**TOWN OF WINTER PARK
PLANNING COMMISSION
Tuesday, August 9, 2022 8:00 AM**

TO Planning Commission
FROM James Shockey, Community Development Director
DATE August 9, 2022
RE PUBLIC HEARING CONTINUED: Final Development Plan (FDP) - Cooper Creek Village, Cooper Creek North, and Cooper Creek South (PLN21-082)

COOPER CREEK VILLAGE SECTION
NORTH PLANNING AREA 1 - LANDSCAPE BUFFER

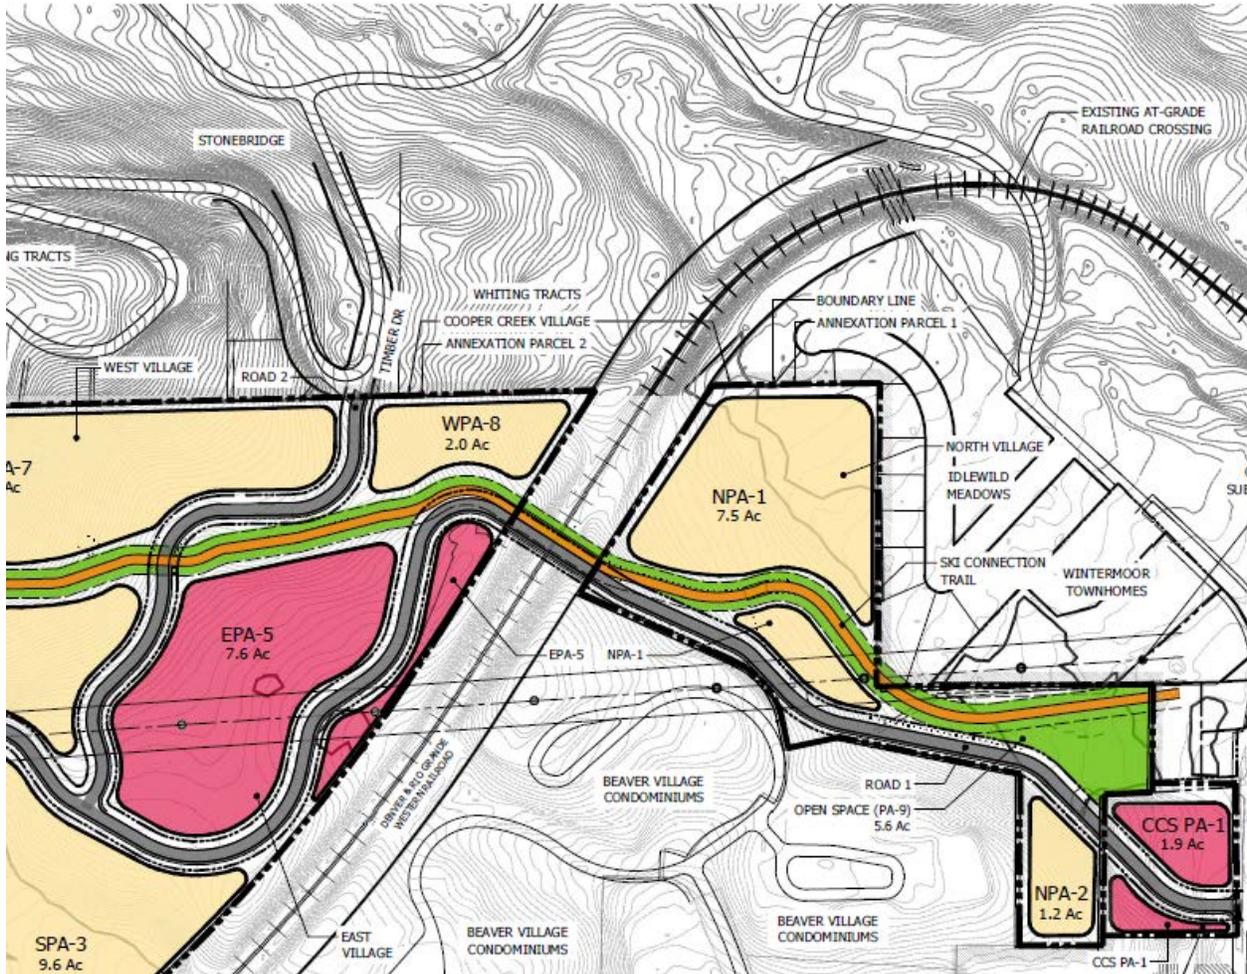
The FDP will incorporate UDC standards. For planning area NPA-1 the Applicant is proposing to create a 30-foot landscape buffer to minimize impacts to the existing single-family homes on Idlewild Lane. The Applicant has not indicated the bufferyard classification they are proposing and that should be indicated in the FDP.
